Detailed Site Plan Library Apartments

DSP-01002-04

STAFF REPORT

SUBJECT: Detailed Site Plan DSP-01002-04
Type 2 Tree Conservation Plan TCP2-050-2023
Library Apartments

Figure 1: Site Plan

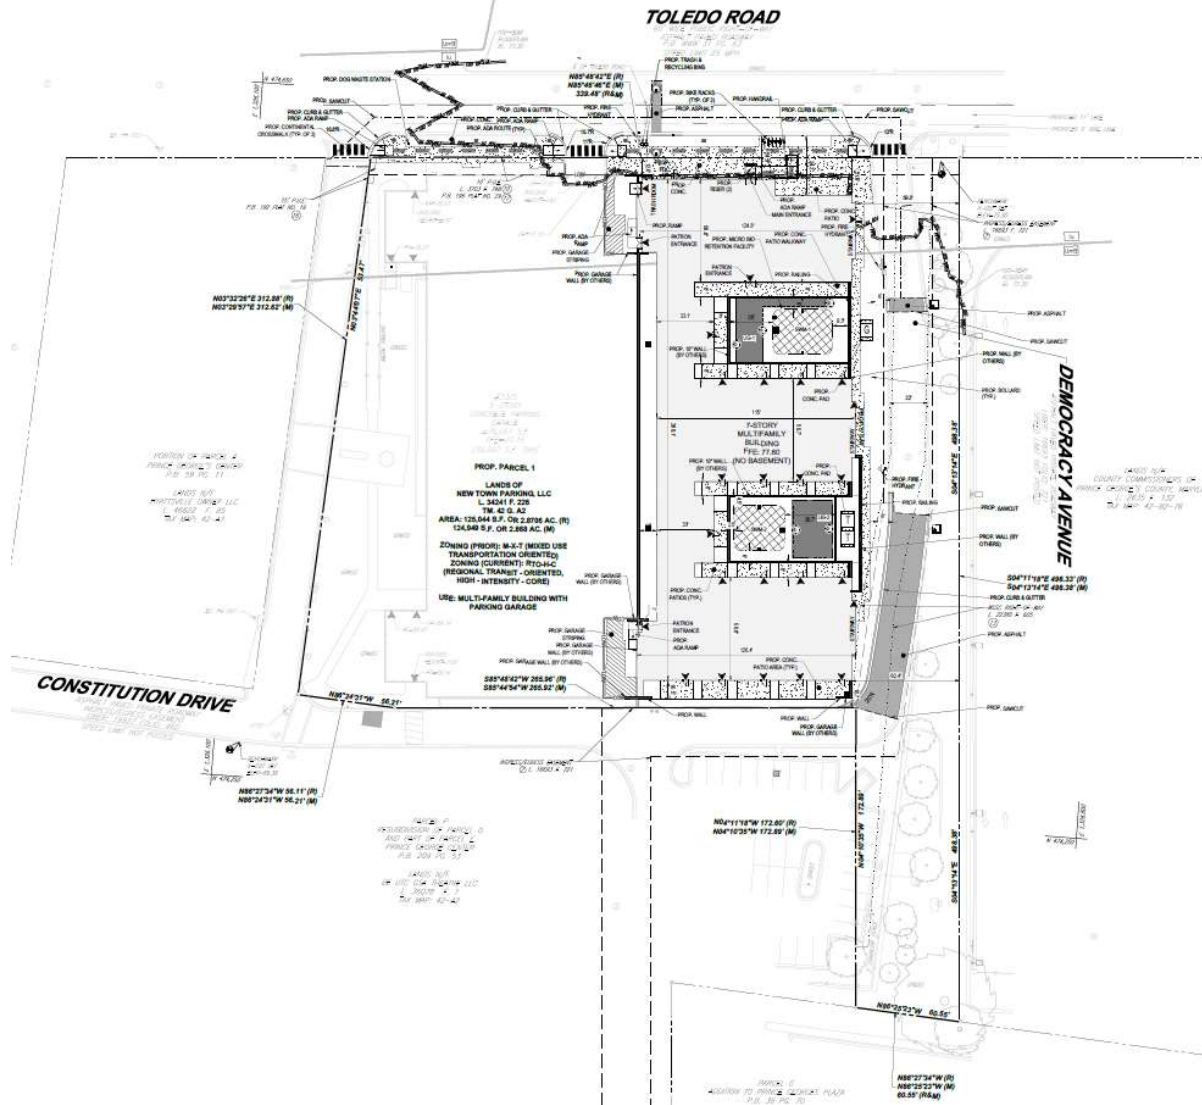
Improved sidewalks around the proposed multifamily building are shown along Toledo Road and Democracy Avenue. Three crosswalks are shown on the plan. One crosses the drive aisle at the entry/exit point of the remaining portion of Garage A on Toledo Road. The other two cross Democracy Avenue and a private roadway to the west of the garage, respectively. These crosswalks connect gaps in the sidewalk network of the area while bringing attention to motorists that pedestrians may be crossing. The Americans with Disabilities Act (ADA) ramps are also incorporated to enhance connectivity. Because the proposed development is through the repurposing of Garage A, the existing retaining walls not only dictate the footprint and placement of the building but also make the construction of a sidewalk along Constitution Drive impossible. If future residents would like to walk to the Hyattsville Crossing (formerly known as Prince George's Plaza) Metro Station and the Mall at Prince George's Plaza, located to the south of the development, they will first use the walkway located to the west of Garage A and cross Constitution Drive to access the sidewalk

Figure 6: Floor Plan of the Recreational Facilities

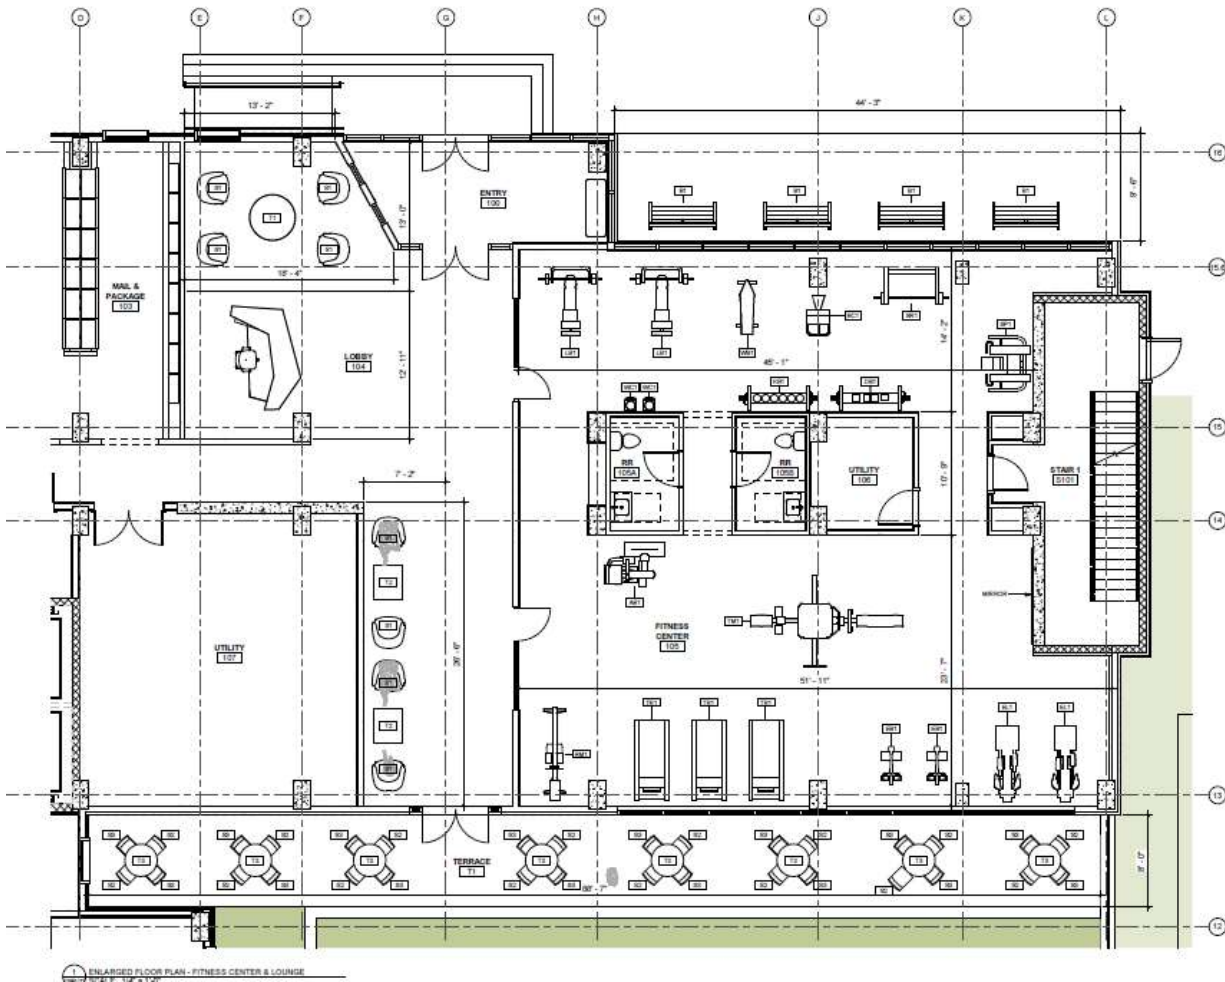
Inside the fitness center, the applicant provides various amenities. The submitted plans also show that there is a discrepancy between the Recreational Facilities Calculation Table on the coversheet and the recreation furniture list on Sheet DSP-22. A condition has been added to ensure information between the calculation table and furniture list is consistent. No bike rooms or courtyard pools are included in this DSP, which is stated in Note 14 in General Notes. A condition is included to update information associated with this note. In addition, this development includes a linear space for a dog run between the proposed building and Garage A. The wall around the dog run is concrete masonry unit blocks and double-paned windows will be used for the openings, all of which prevent sound transfer. A condition is included herein requiring the applicant to provide a dog drinking fountain in the proposed dog run area.

Finally, the applicant also provides street amenities, along Toledo Road, including a dog waste station, bike racks and trash and recycling bins, with details. Conditions are included herein requiring the applicant to provide one dog station, and trash and recycling bins along Democracy Avenue. Additional seating is necessary on both Toledo Road and Democracy Avenue.

Figure 27. Downtown Core Multistory: Commercial, Residential, Institutional Standards

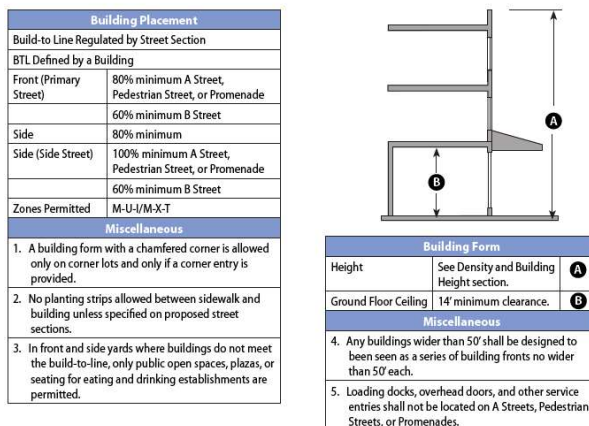
The TDDP Standard requires 100% minimum A Street, Pedestrian Street, or Promenade and 60% Minimum B Street for the side street building placement. A modification is requested to validate existing conditions. The application proposes to raze a portion of the existing garage and construct a multifamily building.
